SUBJECT: NuScale Power, LLC Response to NRC Request for Additional Information No. 281 (eRAI No. 9082) on the NuScale Design Certification Application

NuScale Response to NRC Request for Additional Information eRAI No. 9082

eRAI No.: 9082

Figure 5.4-16: Primary Coolant Temperature Cooldown with Decay Heat Removal System One Train Operation: High System Inventory, 140°F Initial Pool Temperature - 36 Hours

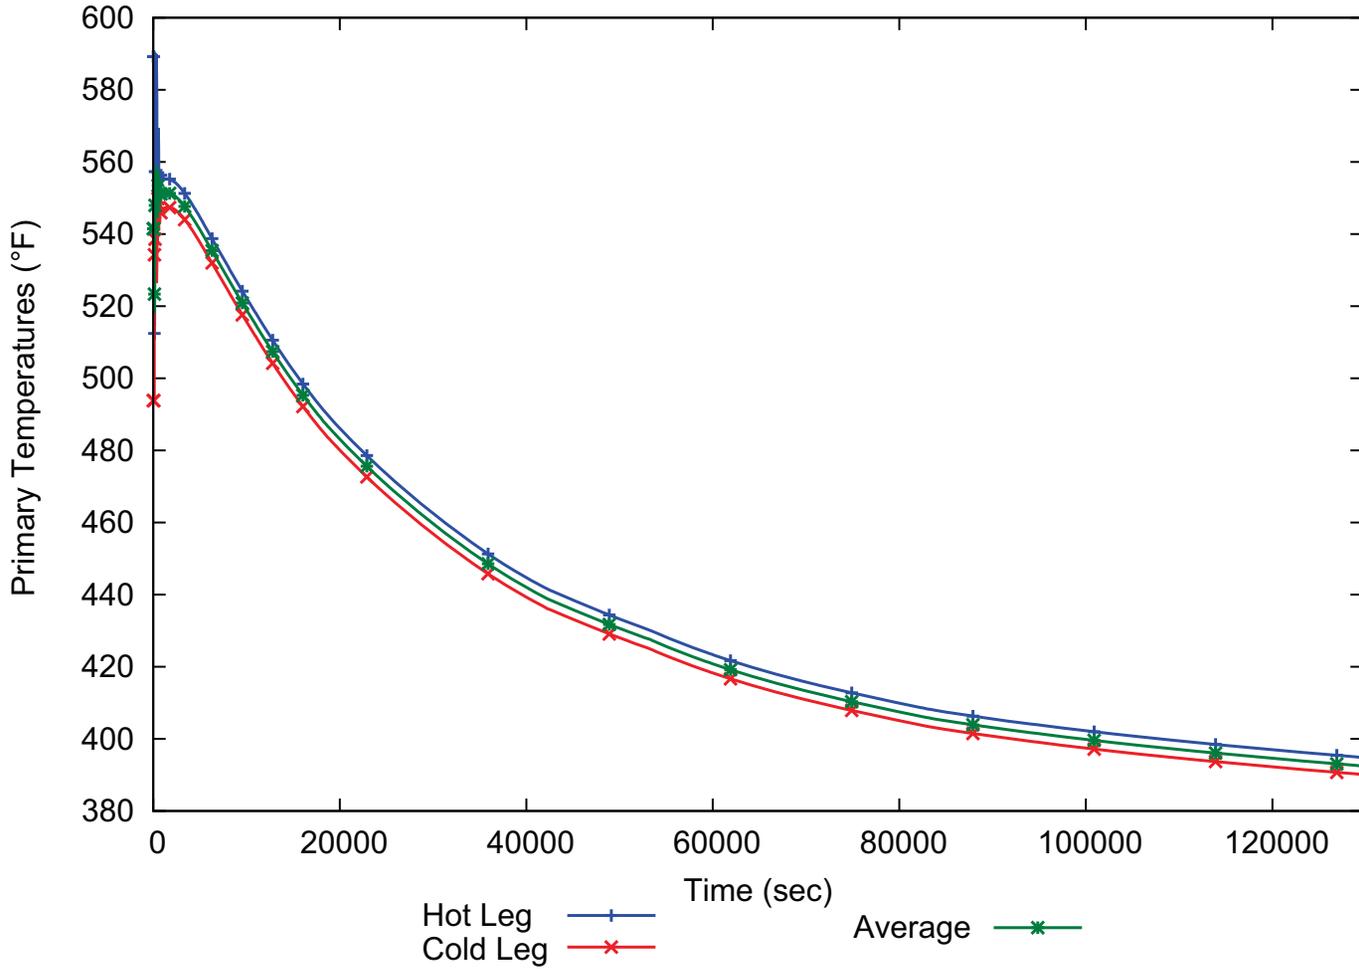
In reviewing the NuScale detailed design documentation during an audit, staff discovered that the initial reactor pool conditions for the cases referred to in the FSAR (Figures 5.4-11 through 5.4-15) were 100F, rather than 140F (the maximum allowed reactor pool value in technical specifications). In FSAR section 5.4.3.3.4, these analyses are referred to as “assuming limiting off-normal conditions”. This statement aligns with the staff’s understanding that the single-train analyses documented are intended to represent bounding analyses for the DHRS performance. Although staff recognizes that NuScale has performed sensitivity studies that demonstrate the DHRS performance for higher reactor pool temperatures, these cases are currently not reflected in the licensing basis documentation. Staff requests that NuScale clarify the description of the limiting DHRS performance in the FSAR by either revising the calculations presented there or adding additional discussion related to the sensitivity cases and characterizing the effect of any conditions that were non-limiting in the cases presented in the FSAR.

FSAR Section 5.4.3.3.4 has been updated to include an off-normal high inventory case with an initial reactor pool temperature of 140°F. A pool temperature of 140°F is consistent with the upper temperature limit of Section 3.5.3 of the Technical Specifications. The results of this additional case are marginally more limiting when compared to the 100°F initial reactor pool temperature case in FSAR Figures 5.4-14 and 5.4-15. The average RCS temperature after 36 hours is 391°F for the 100°F initial pool temperature case and 392°F for the 140°F initial pool temperature case.

Figure 5.4-12 through Figure 5.4-15 show the RCS cooldown response during transient cases with one DHRS train in operation assuming low and high DHRS inventories. These off-normal transient cases assume the an initial reactor pool temperature of 100 degrees F and reduced heat removal capability due to fouling, SG tube plugging, and accumulation of noncondensable gases. Figure 5.4-12 and Figure 5.4-14 show the RCS cooldown over 4 hours and Figure 5.4-13 and Figure 5.4-15 show the RCS cooldown over 36 hours. The low DHRS inventory case indicates that RCS average temperature stabilizes below 350 degrees F within 36 hours and the limiting high DHRS inventory case indicates that RCS average temperature stabilizes below 400 degrees F within 36 hours. An additional high DHRS inventory case is run using an initial reactor pool temperature of 140 degrees F. This pool temperature is consistent with the upper limit temperature in Section 3.5.3 of the Technical Specifications. The results in Figure 5.4-16 show that the limiting reactor pool temperature of 140 degrees F has a small effect on the RCS temperature after 36 hours compared to the 100 degrees F initial condition. Based on these results, the DHRS design is capable of cooling the RCS to below a safe shutdown temperature of 420 degrees F in less than 36 hours with one DHRS train in operation assuming limiting off-normal conditions and a single active failure of the associated MSIV to close.
